DEPARTMENT OF THE ARMY
NEW ENGLAND DISTRICT, CORPS OF ENGINEERS
696 VIRGINIA ROAD
CONCORD, MASSACHUSETTS 01742-2751

Regulatory Division
CENAE-R-PEA
Permit Number: NAE-2009-349

In accordance with your recent request, your Department of the Army permit, number NAE-2009-349, is hereby modified. The modified work is proposed at a 15 acre site in Vineyard Sound approximately 0.8 miles offshore of Chilmark, Massachusetts and is described on the enclosed plans entitled, "Proposed Aquaculture Site, Offshore – Chilmark, MA," on two sheets.

Proposed Aquaculture Site Offshore - Chilmark, MA

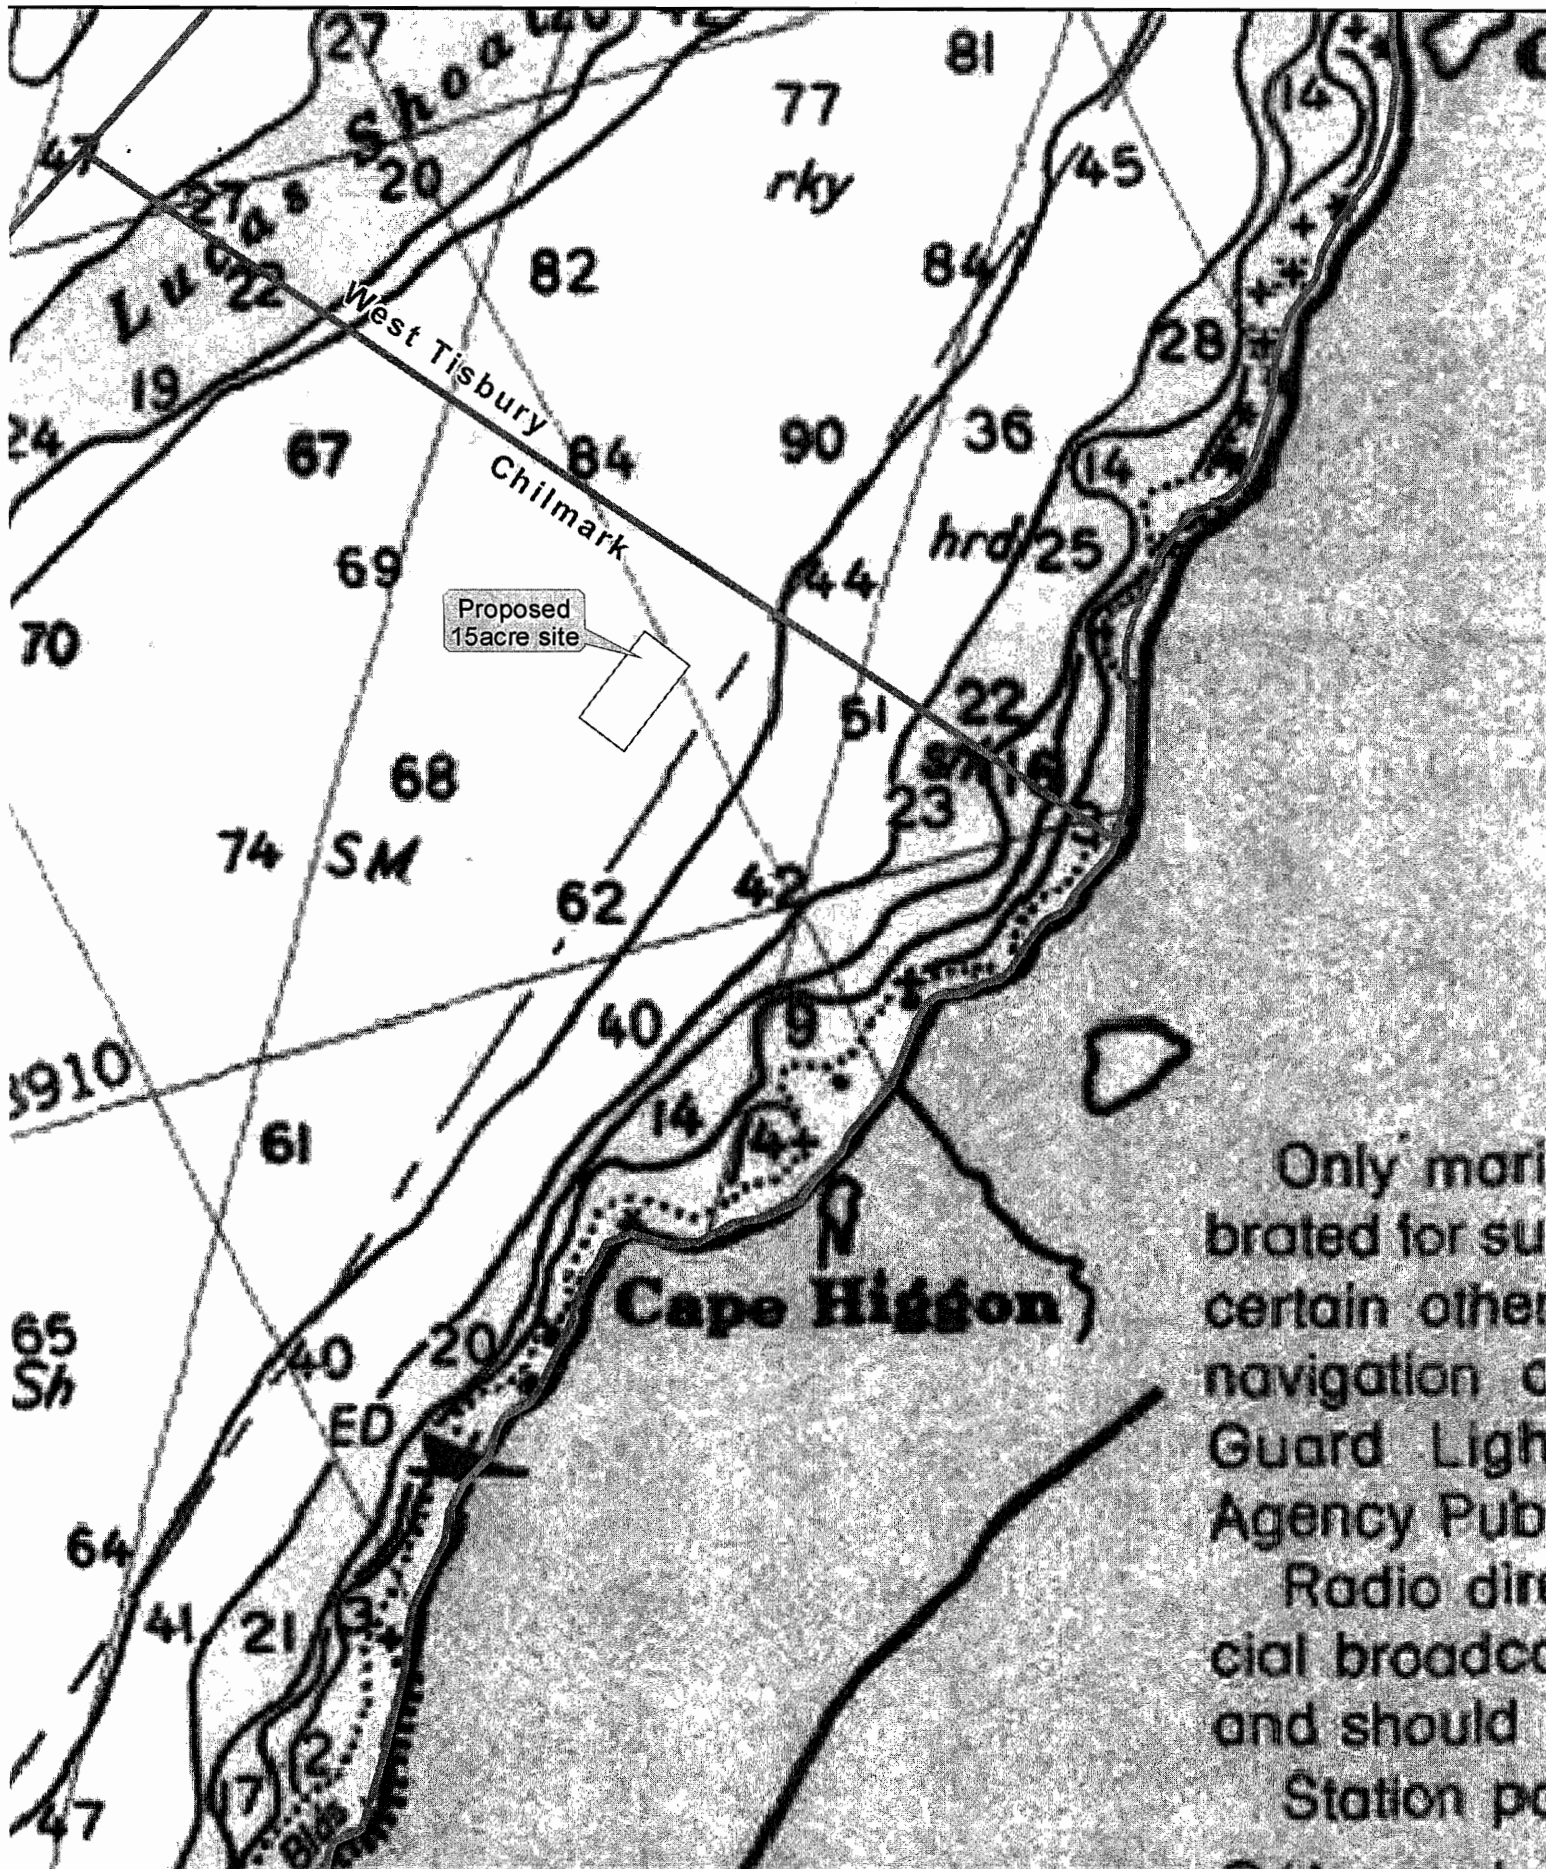
A Corps of Engineers permit was previously issued to the Town of Chilmark in October, 2009, for one pilot longline within the 15 acre area. The Town has now requested the deployment of nine additional longlines within the 15 acre area for a total of 10 longlines. The Town has also requested that the 15 acre area be rotated 90 degrees and that the 10 longlines be deployed in groups of two in series to take advantage of the prevailing longshore current and to allow each group of two longlines to share a middle anchor. The groups of two longlines will be deployed in series parallel to the prevailing current with the necessary distance between the lines to allow the passage and maneuvers necessary for service vessels to work the lines.

The proposed work involves the placement of 10 submerged longline structures in groups of two in series below the mean high water line within a 15 acre subtidal area for mussel cultivation. Each longline will consist of 1.12 inch polysteel longline anchored by two 4,000 kg concrete deadweight anchors. Each group of two longlines will require three anchors as they will be in series and will share an anchor. Additional intermediate 30 kilogram concrete block anchors may be installed at 7 meter intervals along each longline to hang to the bottom.

Buoyancy will be achieved with two 24 inch diameter circular plastic submerged floats located at each end of the horizontal section of the longlines as well as intermediate 16 inch diameter circular plastic floats spaced as needed along the horizontal sections. The distance between anchors will be 165 meters and the horizontal longline length between end floats will be 117 meters. The submerged depth for the longlines will be 8 meters. At the water's surface, there will be five marking buoys per longline.
